ADDENDUM I

**REQUEST FOR PROPOSALS (RFP) # SAAF-1-2024 (1012)
“SITE DEVELOPMENT AND CONSTRUCTION-STARKEY ADMINISTRATION AND
ANNEX FACILITIES”**

ADDENDUM 01
REQUEST FOR PROPOSALS (RFP) # SAAF-1-2024 (Oracle # 1012)
“DEVELOPMENT AND CONSTRUCTION-STARKEY ADMINISTRATION AND ANNEX FACILITIES”

Questions (Q) and Answers (A)

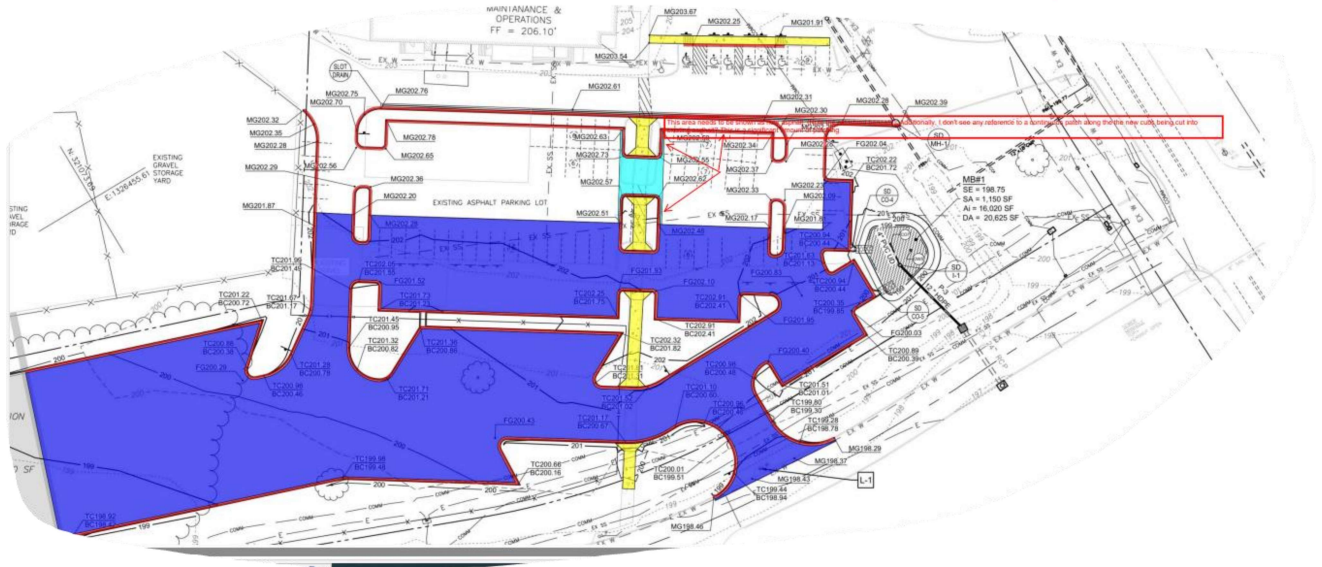
- Q8. This area needs to be shown as new asphalt. (Note the old island beneath). Additionally, I don't see any reference to a continuous patch along the new curbs being cut into existing asphalt? This is a significant amount of patching.

- A8. Plan revised to include full depth asphalt pavement section in area of existing curb island. See Re-issued Plans C5.0, C7.0 and C7.1 in Bid Addendum 01.**
